ITEM 6 - BAYWOOD 2022

KPB File No.	2022-129
Plat Committee Meeting:	September 26, 2022
Applicant / Owner:	James Barlow of Homer, AK
Surveyor:	Gary Nelson / Ability Surveys
General Location:	East End Road, Old East End Road, Fritz Creek area / Kachemak APC

STAFF REPORT

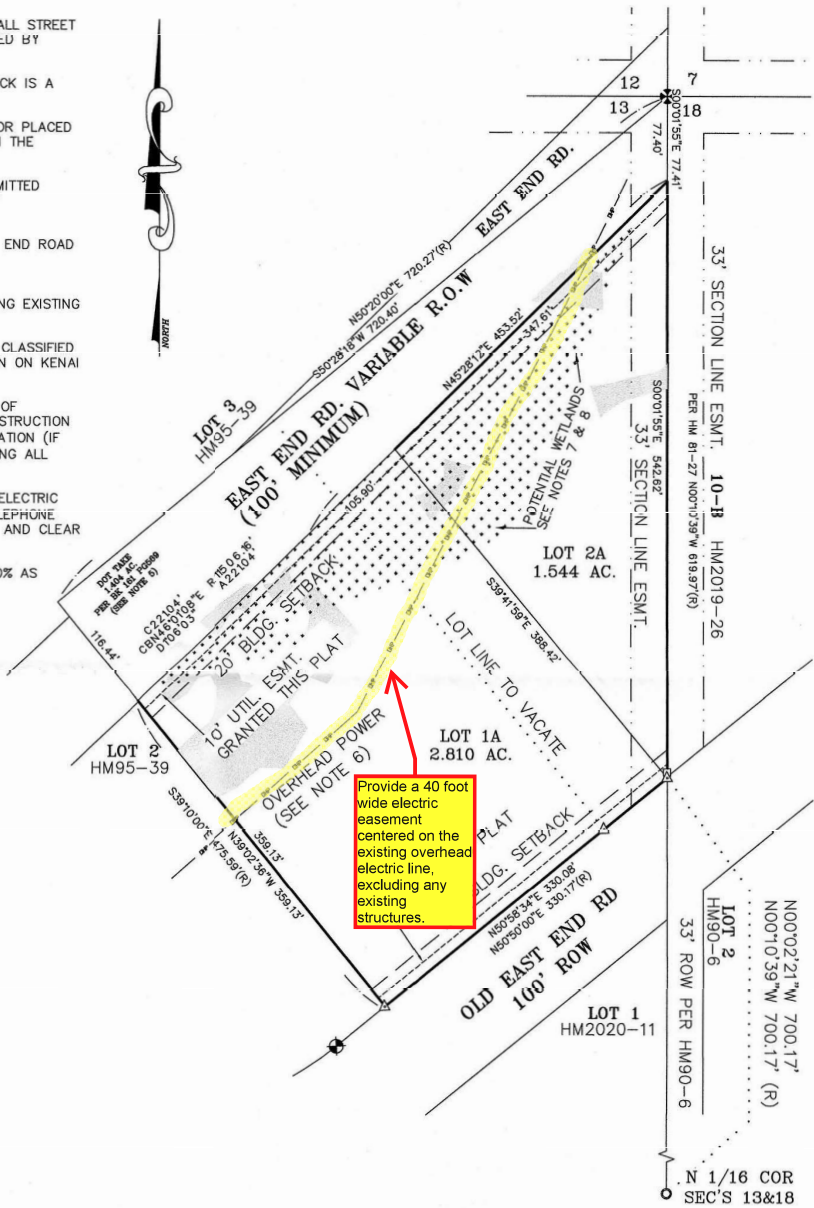
Site Investigation: There are some areas of steep slope as shown on the plat. Per KPB GIS data, contours in the southeast portion are an even grade towards Old East End Road. The northern portion contains low wet areas and are depicted. Plat note 8 states to contact the Corps of Engineers for wetland determination. **Staff recommends the wetlands remain on the final plat and add to Note 8 "U.S." to the Army Corps.**

Utility Easements The parent plat granted a 10 foot utility easement along the western lot line of parent Lot 1 to connect with a 20 foot wide utility easement centered on an existing overhead powerline. The plat is carrying over the 20 foot utility easement but will need to carry over the 10 foot along the western boundary. **Staff recommends the 10 foot utility easement be carried over and it be noted that it was granted per HM 81-27.**

The plat was sent to utility providers for comment. Homer Electric Association has requested the easement over the existing overhead powerline be increased to 40 feet and will exclude any existing structures. The surveyor should verify the structures, if any, that will be within the additional easement and not such structures on the final. The plat note in place should be updated and should include reference to any existing structures, if any. **Staff recommends the easement be extended and plat note 6 be revised, "Per HM 81-27 there is a 20' utility easement along existing powerline. This plat will be granting additional width to the easement that will be 40 feet wide centered on the existing overhead powerline. The existing structures of _____ within Lot 1A predates the additional granting of the utility easement. The structure is only subject to the 20 foot utility easement as created on plat HM 81-27."**

Per KPB 20.60.070, the scale will need to be changed to be compliant.

Staff recommendation: *Verify acreage and update.*

Staff recommendation: *Update the section label for section 17.*

Staff recommendation: *Add street name for dedication south of Old East End Road of Langhus St. N.*

Platting Staff Comments: A soils report will be required for Lot 2A.

Staff recommendation: *Use heavier line weight on the northwest line of Lot 1A along East End Road.*

- *Wastewater notes will be required.*
- *Revise plat note 6 as needed per the utility easement request.*

Staff recommendation: *The owner took title with middle initial and without. The certificate of ownership should include both by using "aka" or "also took title as". Comply with 20.60.190.*

Provide a 40 foot wide electric easement centered on the existing overhead electric line, excluding any existing structures.
